Docket No. 50-336

Millstone Nuclear Power Station, Unit No. 2
Proposed Revisions to Technical Specifications

Power Distribution Limits

January, 1984

FIGURE 3.2-3 Total Radial Peaking Factor Versus Allowable Fraction of Rated Thermal Power

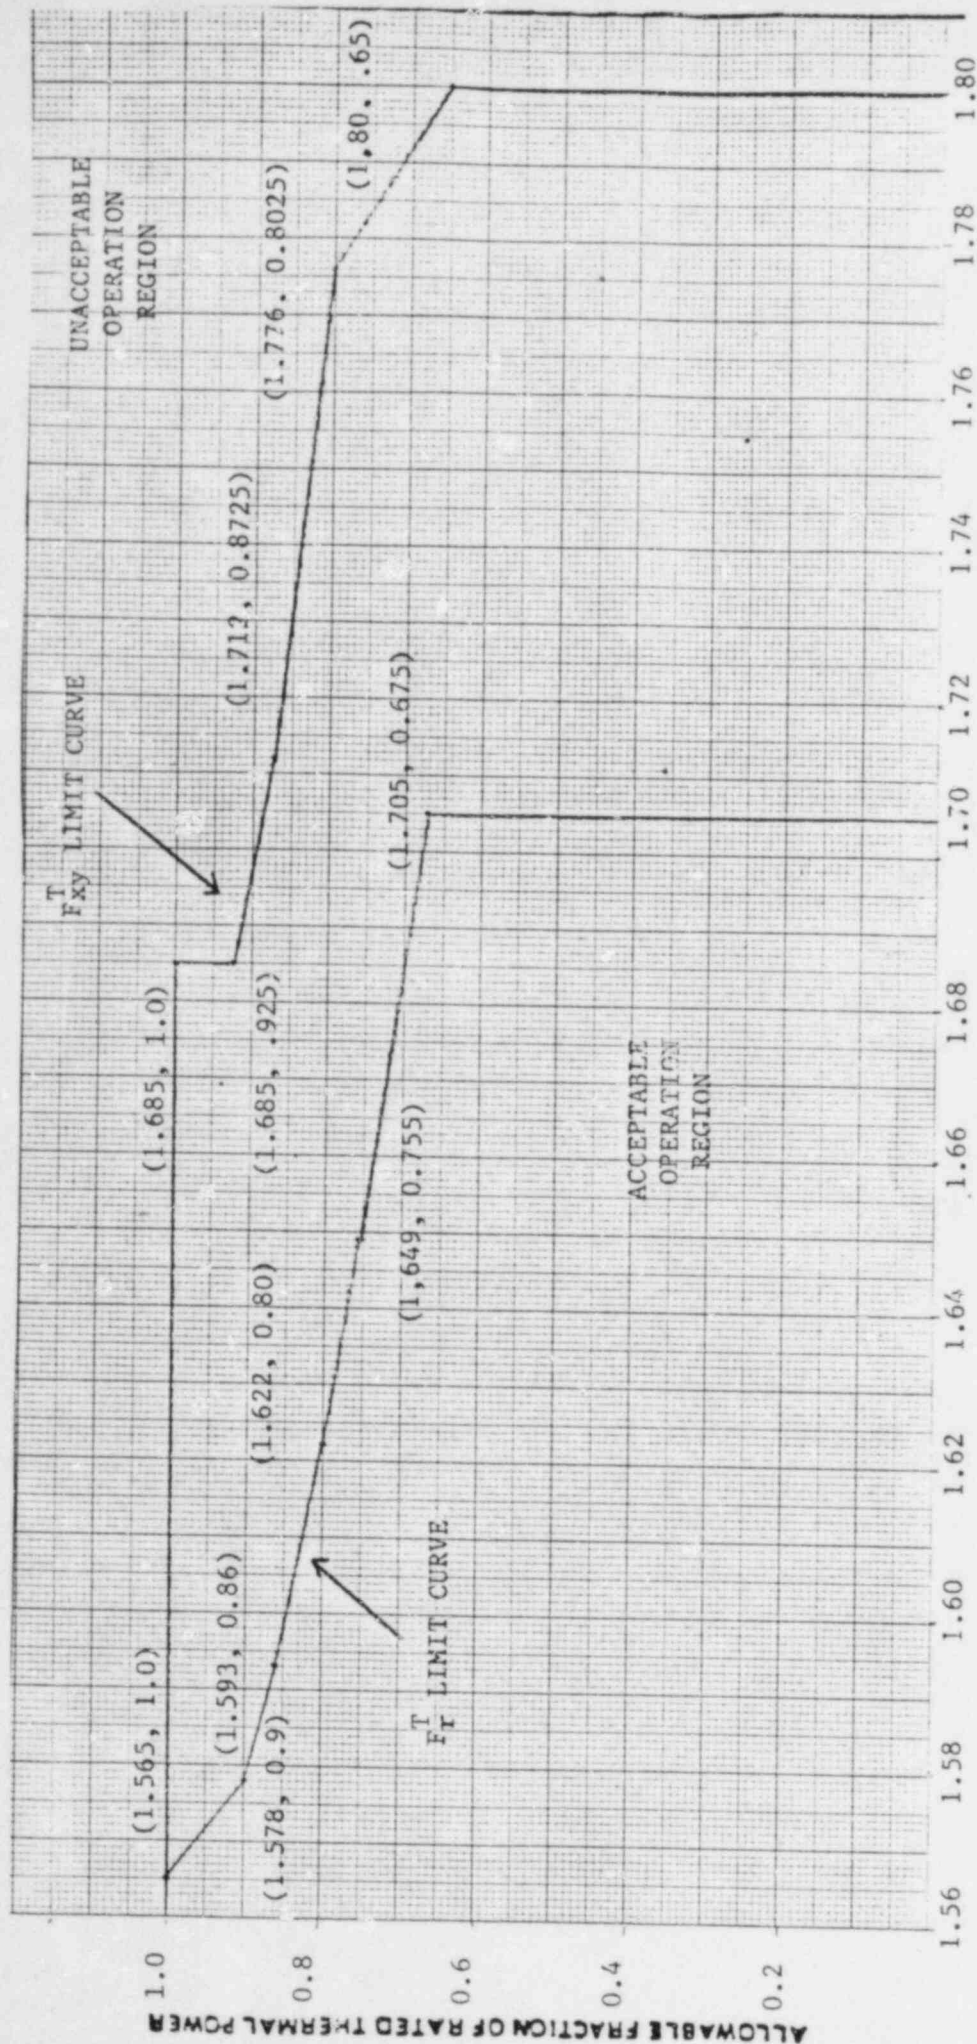
3.2.2 The calculated value of F_{xy}^T , defined as $F_{xy}^T = F_{xy} (1+T_q)$, shall be limited to ≤ 1.685 .

With $F_{xy}^T \geq 1.685$, within 6 hours either:

- a. Reduce THERMAL POWER to bring the combination of THERMAL POWER and F_{xy}^T to within the limits of Figure 3.2-3 and withdraw the full length CEAs to or beyond the Long Term Steady State Insertion Limit of Specification 3.1.3.6; or
- b. Be in at least HOT STANDBY.
